Re: Brickhaven No. 2 Mine Tract A
Mining Permit No. 19-25 – Proposed Modification

On behalf of Green Meadow, LLC and Charah, Inc., HDR submitted a permit modification for the Brickhaven No. 2 Mine, Tract A to your attention on June 16, 2015. The modification included the addition of a rail spur in the northwest corner of the site. We have coordinated review of the modification package with Ms. Wehner of your staff and are submitting herewith two copies of the final amended modification package. A pdf file is also provided with this letter via email. A check for the required fee was provided with the original submittal. Following is a brief description of the changes made from the initial submittal.

Charah
BRICKHAVEN No. 2 MINE TRACT "A"
MINE PERMIT TRANSFER/MODIFICATION
MONCURE, NC

SHEET
02C-03

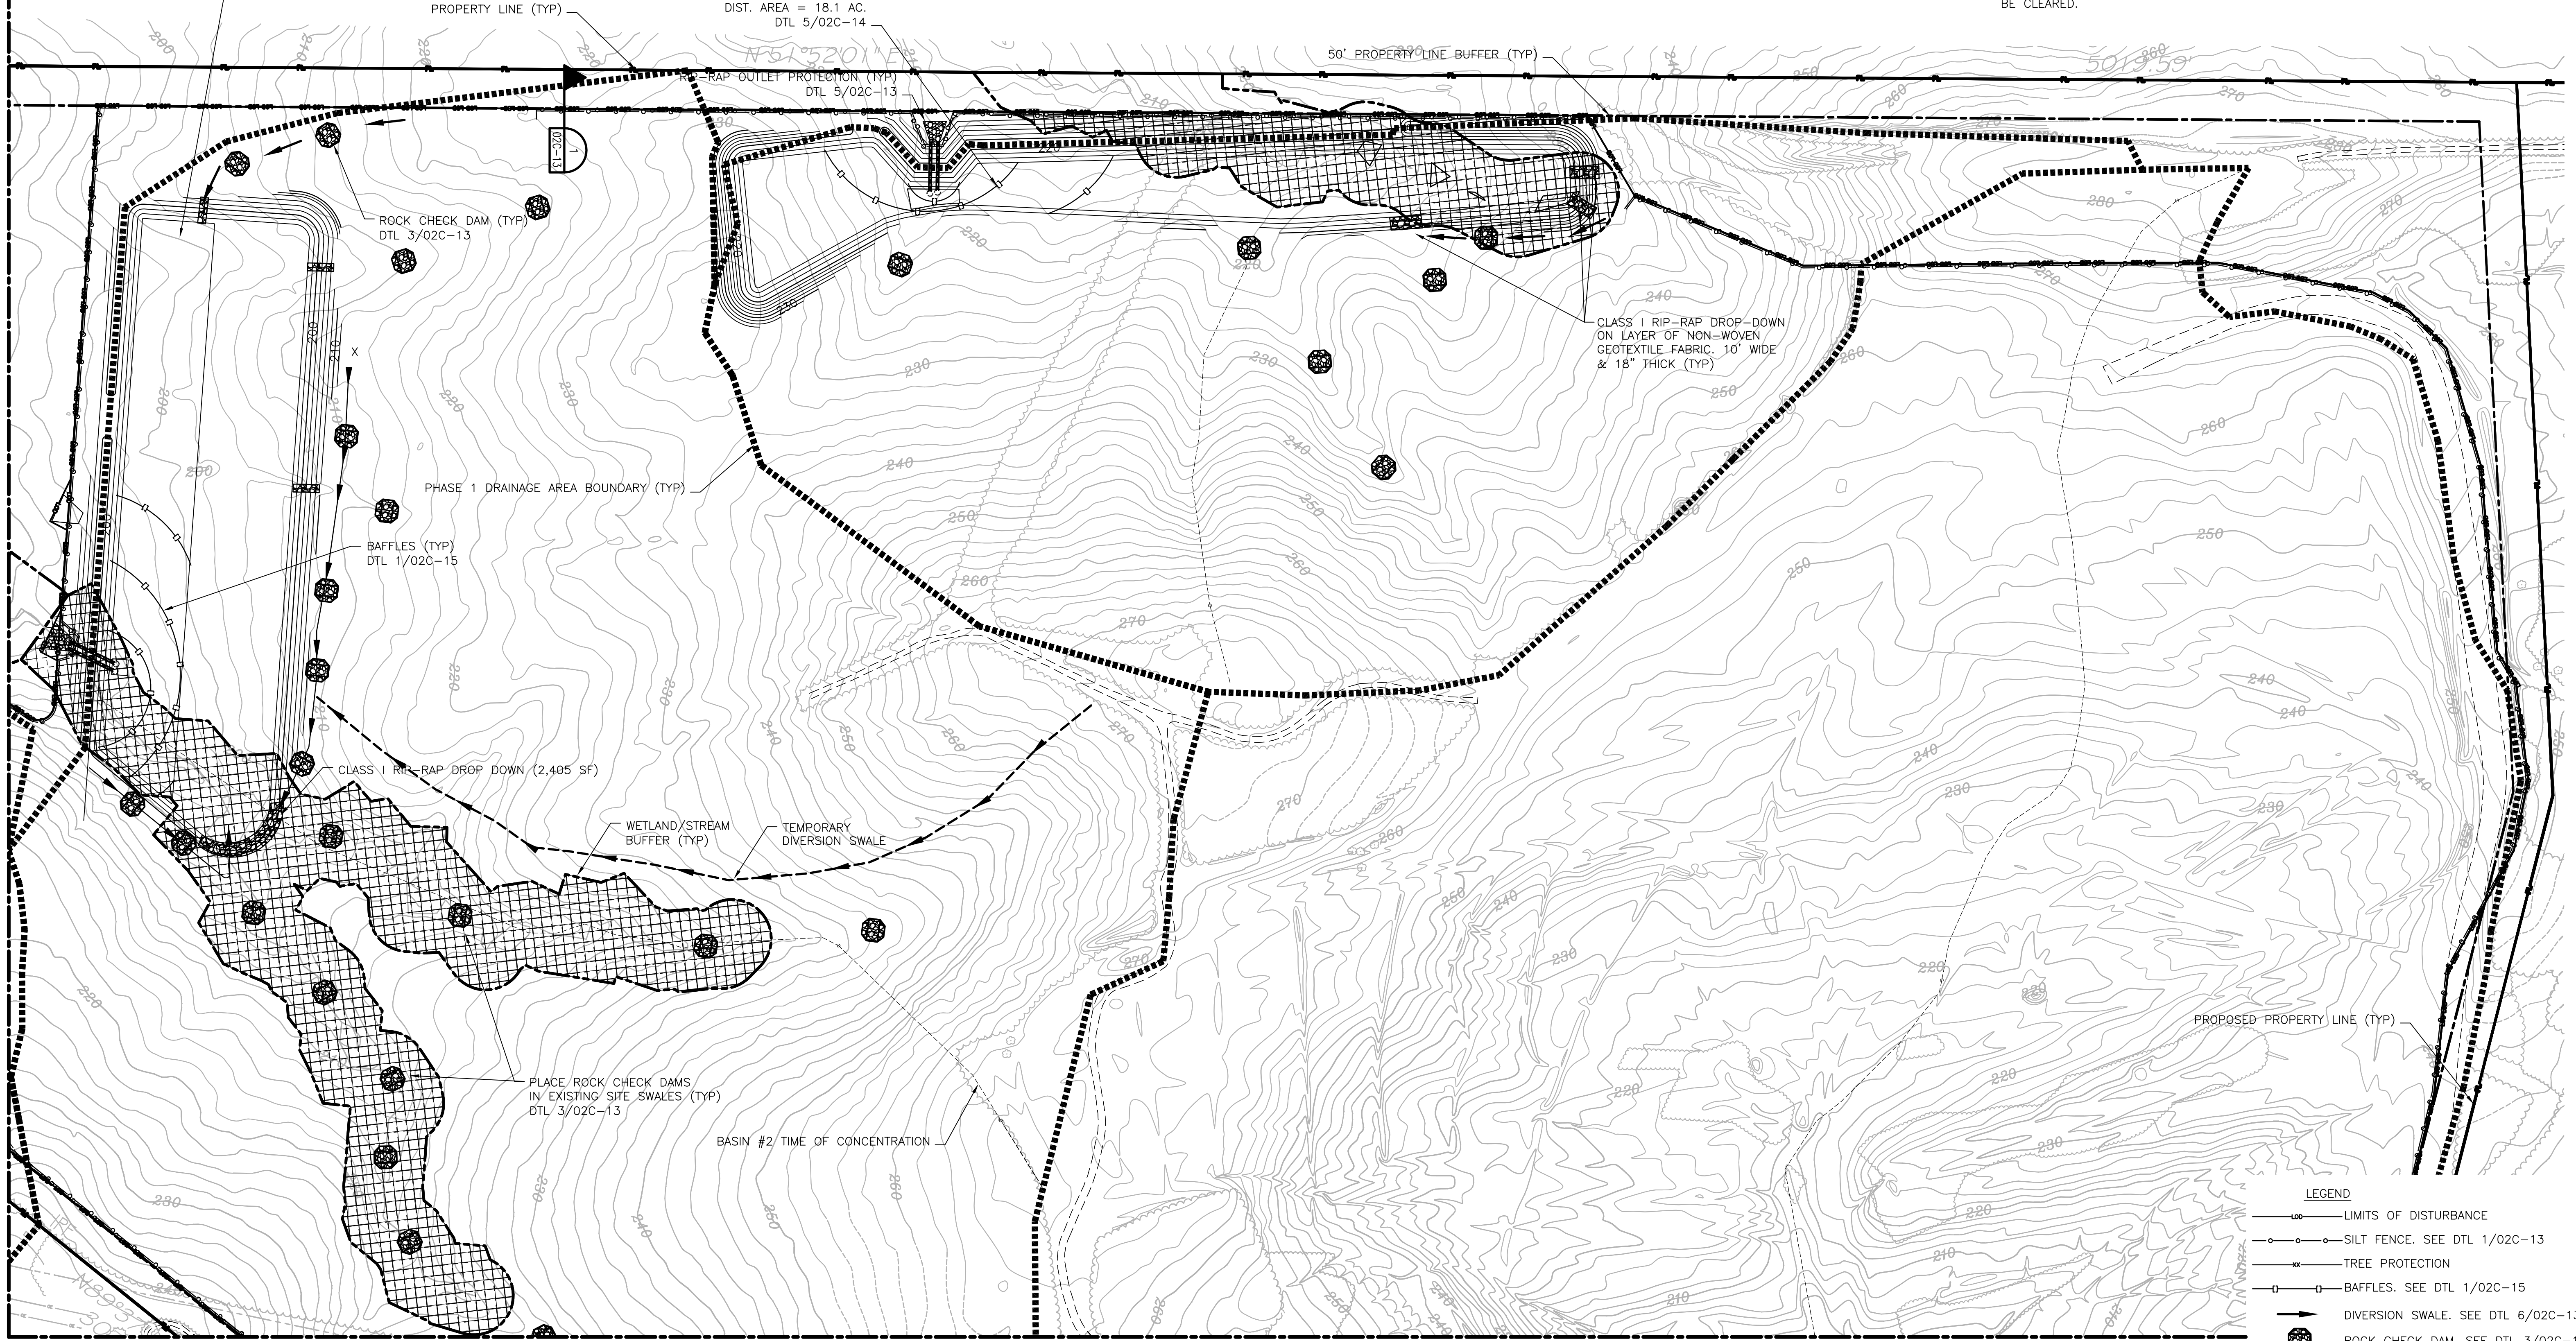
ISSUE	DATE	DESCRIPTION
C	07/2015	ADDED TEMPORARY DIVERSION SWALE TO SB#2
B	12/31/14	REVISED PER NCDENR COMMENTS
A	11/2014	ISSUED FOR APPROVAL

EROSION AND SEDIMENTATION
CONTROL PLAN - PHASE 2
PLAN 2

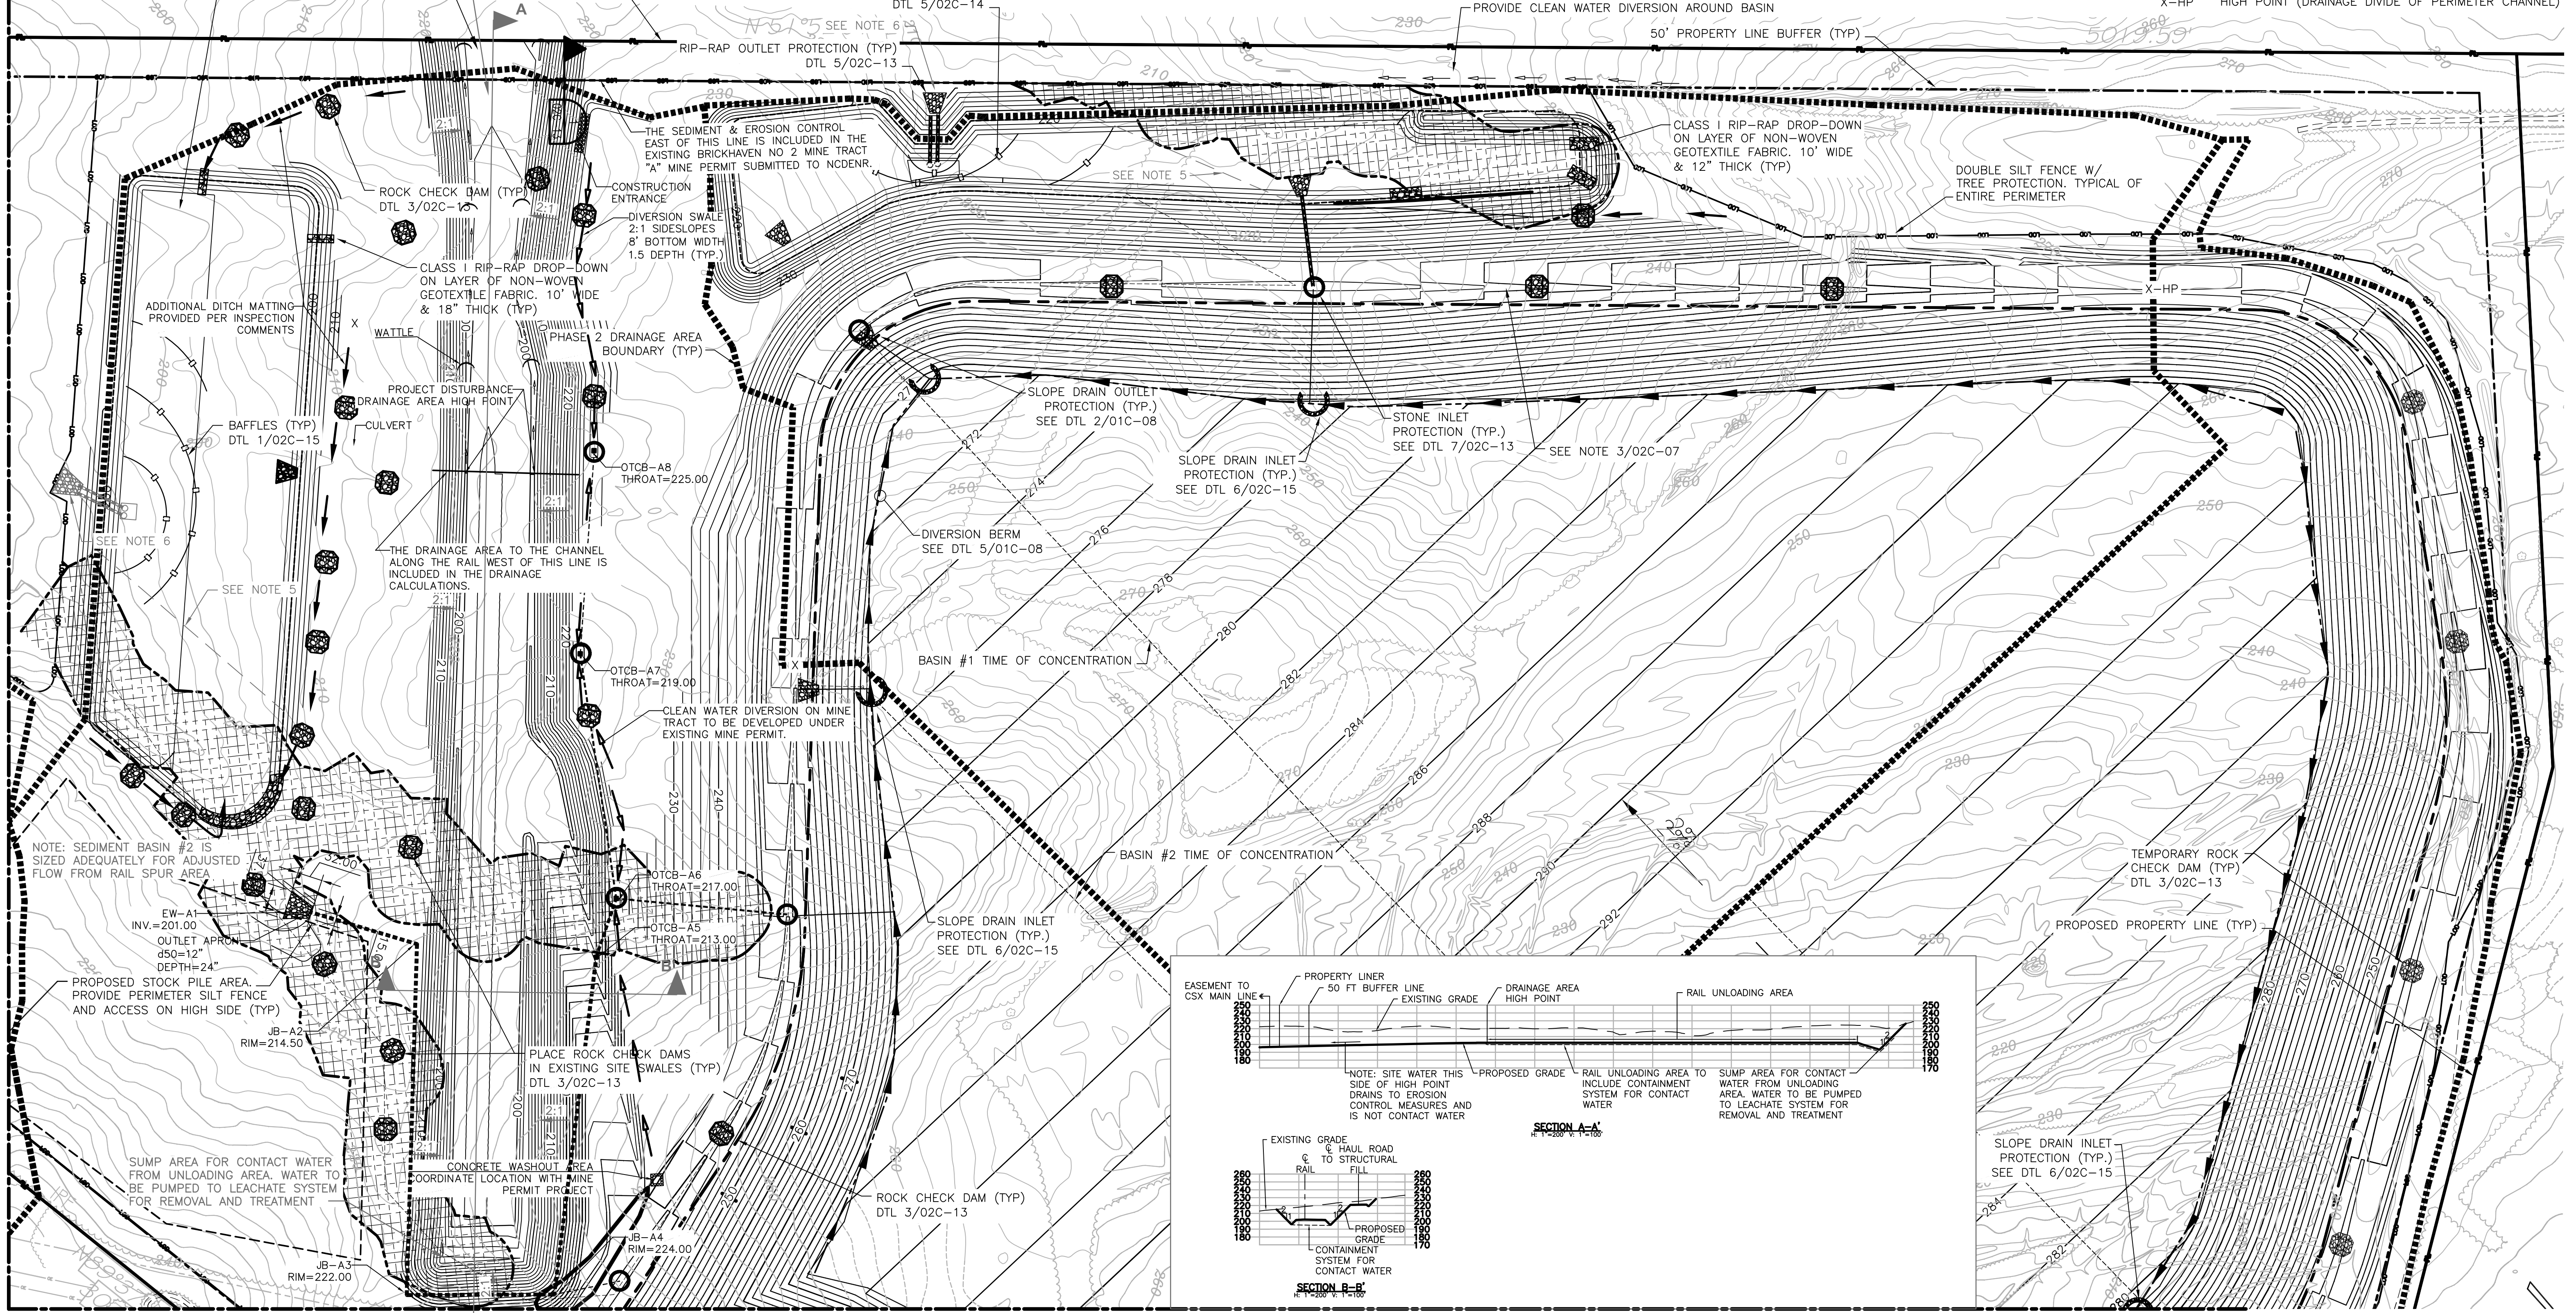
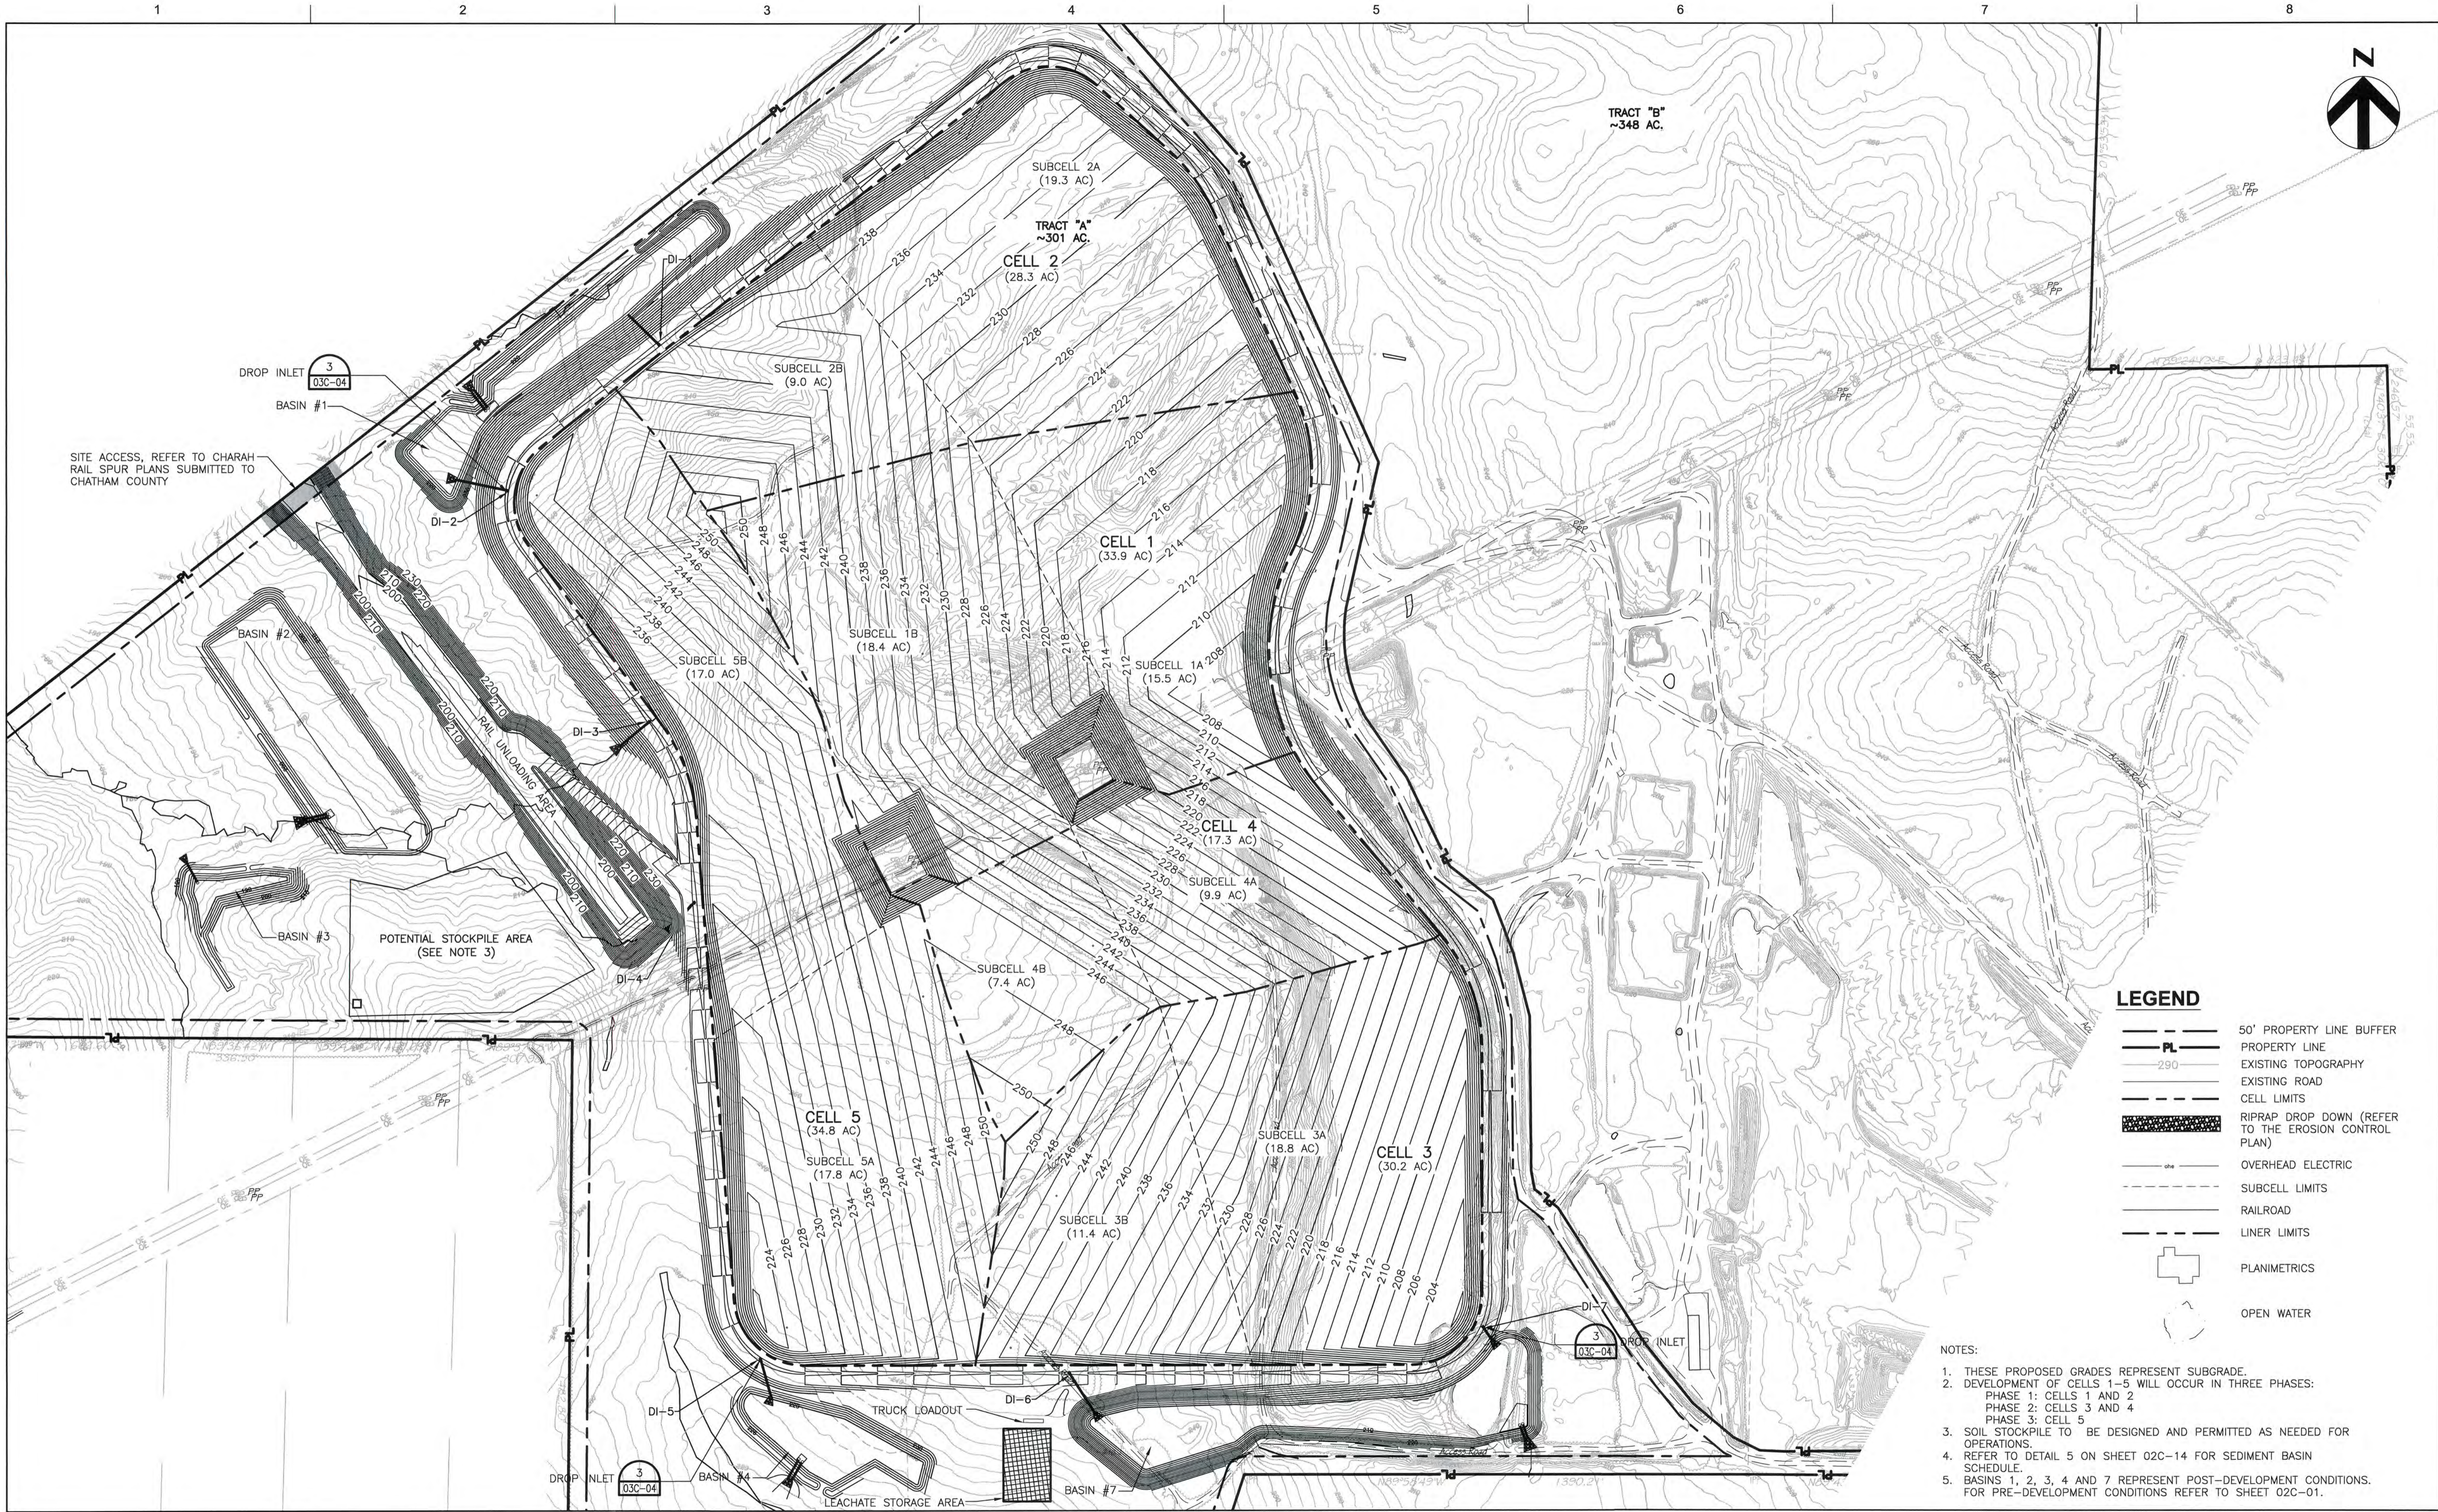
- Drawing 02C-09, Erosion and Sedimentation Control Phase 2 Plan 2, has been modified to include additional detail regarding the stormwater drainage system in the area of the proposed rail spur and also to include sedimentation and erosion control enhancements recommended by DEMLR staff during site inspections.
- Calculations have been included for the stormwater piping network leading to Sediment Basin No. 2 as depicted on drawing 02C-09.
- Drawing 02C-03, Erosion and Sedimentation Control Plan – Phase 1, Plan 2, has been added to the modification package. This drawing is part of the original mine drawings and has been amended to depict a diversion swale installed adjacent to the wetland buffer to better route stormwater into Sediment Basin No. 2. This diversion was recommended by DEMLR staff during site inspections.

ISSUE	DATE	DESCRIPTION	PROJECT NUMBER
D	07/14/15	ADDED DETAIL TO RAIL UNLOADING AREA	453925-237673-018
C	06/2015	ADDED RAIL UNLOADING AREA	
B	12/31/14	REVISED PER NCDENR COMMENTS	
A	11/2014	ISSUED FOR APPROVAL
